ADDENDUM #3 – ITT No. ENG 23 – 01

Tillicum and Lampson Active Transportation Improvements

May 24, 2023

DRAWN BY: D.L.	CHK'D BY: J.M.	ENGINEER: J.M.
1 OF 1	SURESPAN PROJ. NO.	QUANTITY: 1 DRAWING NO.: BBL-1

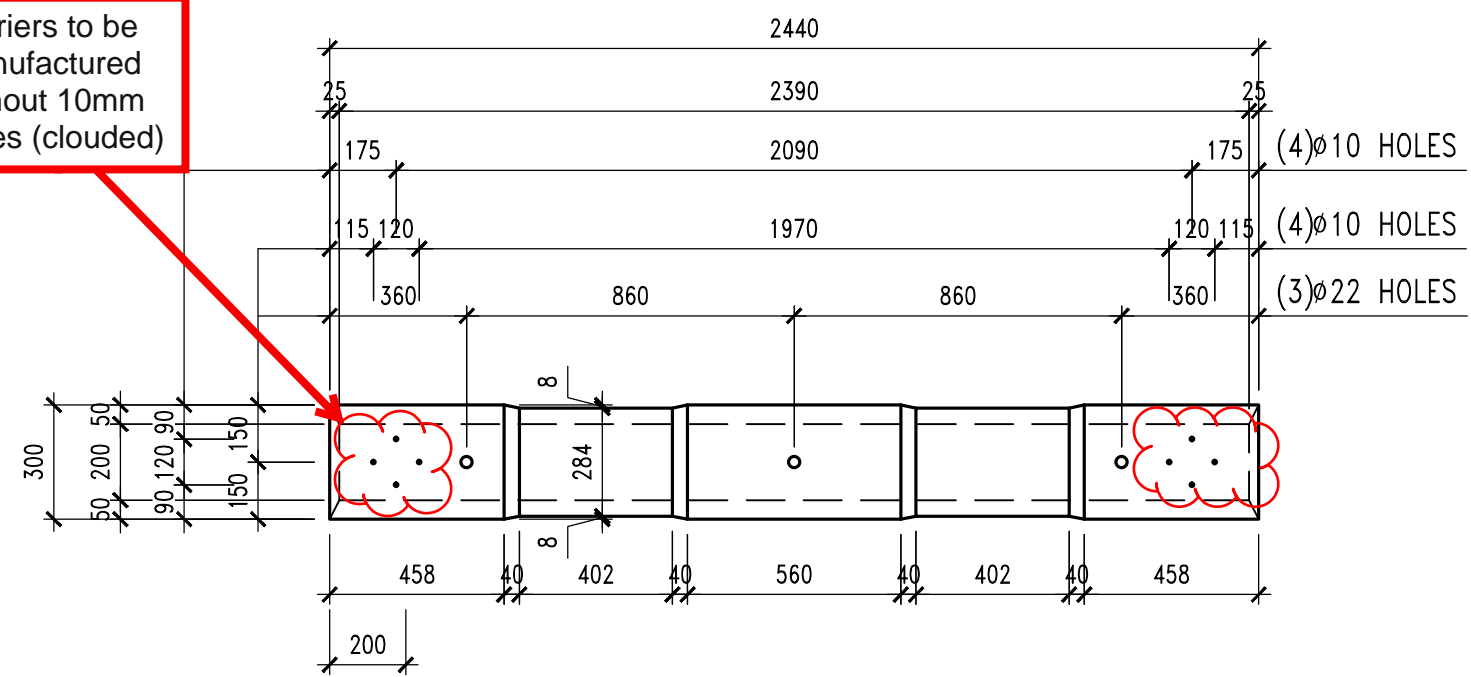
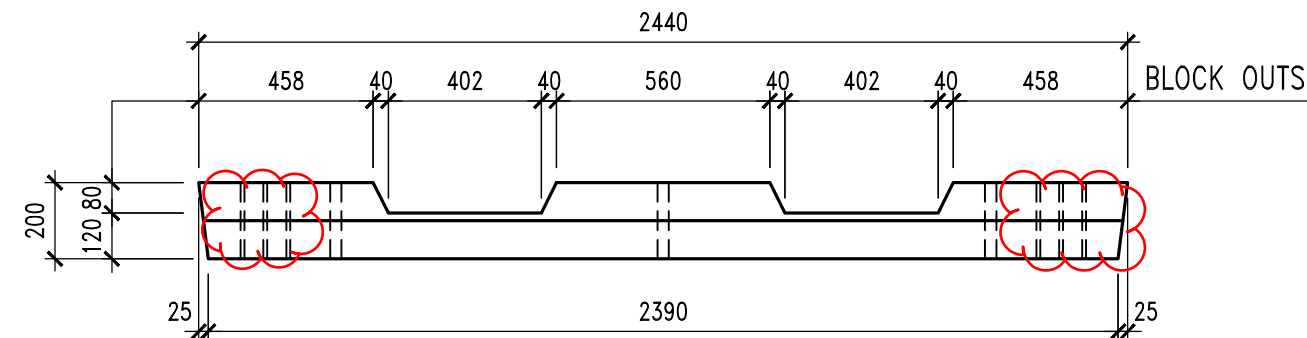
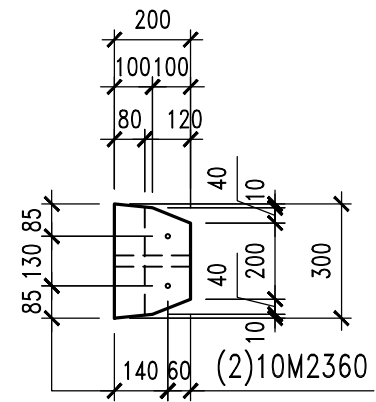
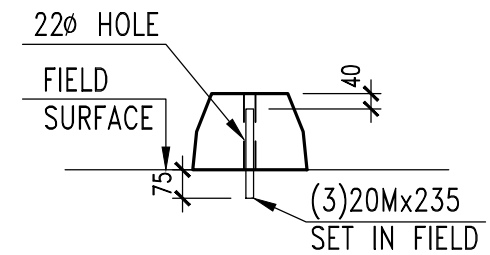
Barriers to be manufactured without 10mm holes (clouded)

Answer #1: Yes, Surespan curbs as per the attached shop drawings (including markups) are a suitable alternative. Single bull nose should be used for every start and stop of barriers. Double bull nose should be used in cases where there is only a single barrier.

PROJECT: BARRIERS FOR PROTECTED BIKE LANES			
DRAWN BY: T.M.	CHK'D BY: J.M.	ENGINEER: J.M.	
1 OF 1	SURESPAN PROJ. NO.	QUANTITY 1	DRAWING NO. BBL-2

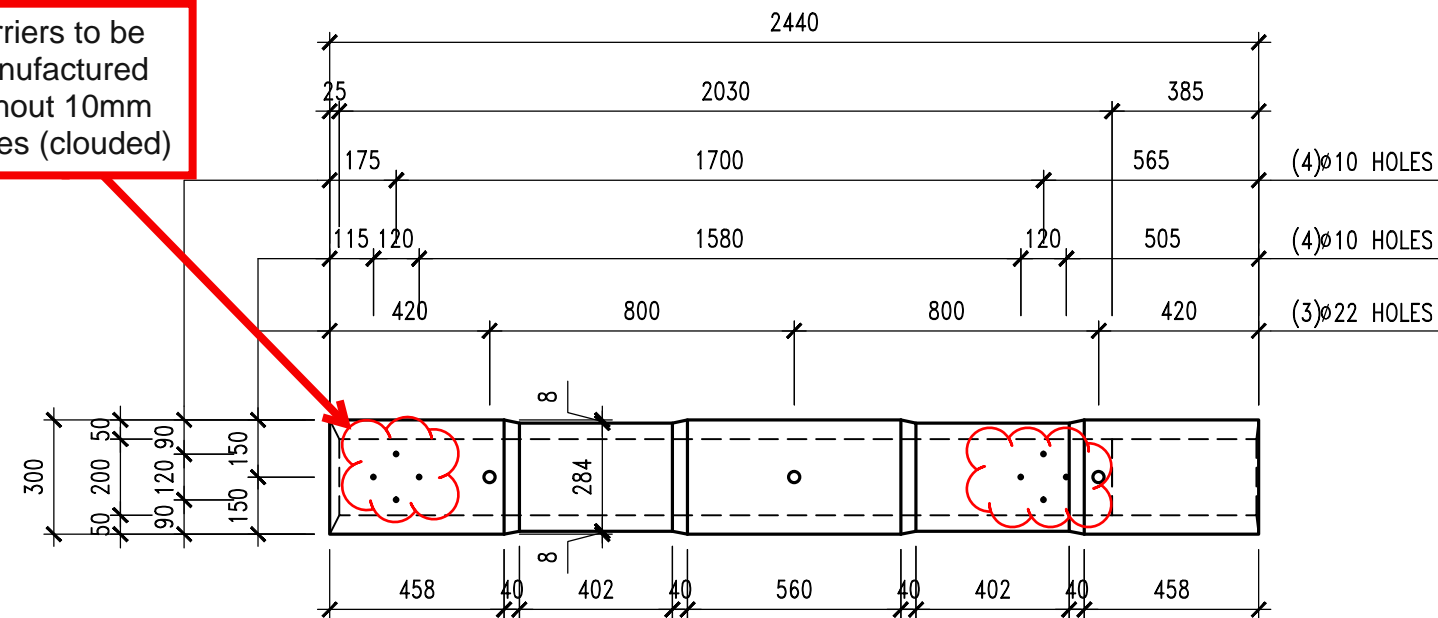
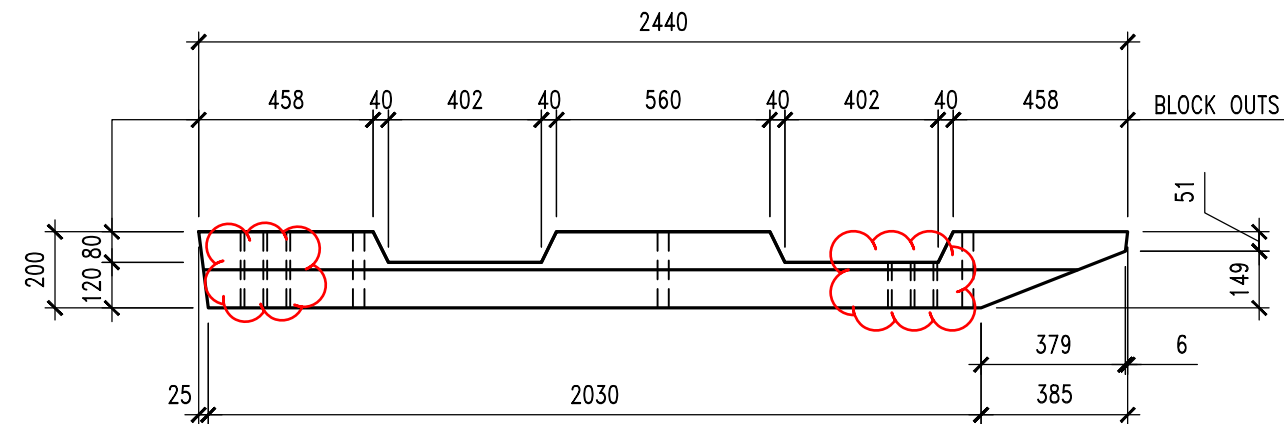
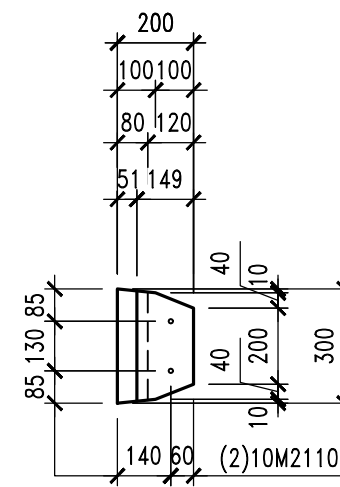
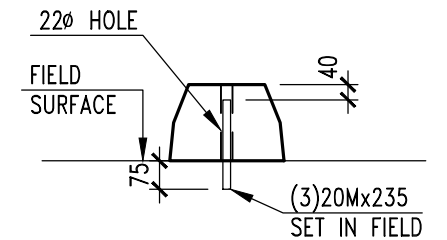
Barriers to be manufactured without 10mm holes (clouded)

PROJECT:			
BARRIERS FOR PROTECTED BIKE LANES			
DRAWN BY:	CHK'D BY:	ENGINEER:	
T.M.	J.M.	J.M.	
1 OF 1	SURESPAN PROJ. NO.	QUANTITY	DRAWING NO.
		1	BBL-3

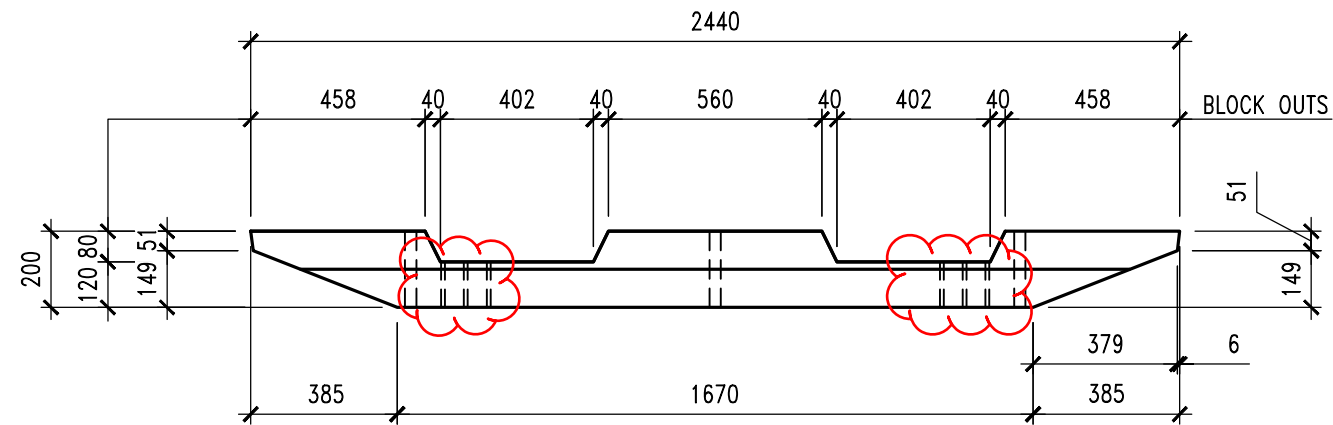
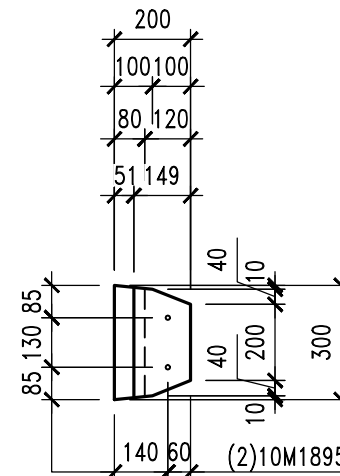
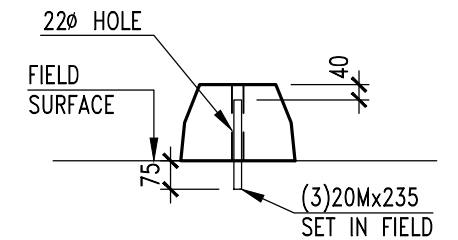
A red arrow points to a clouded area in the cross-section, indicating a specific detail or note.
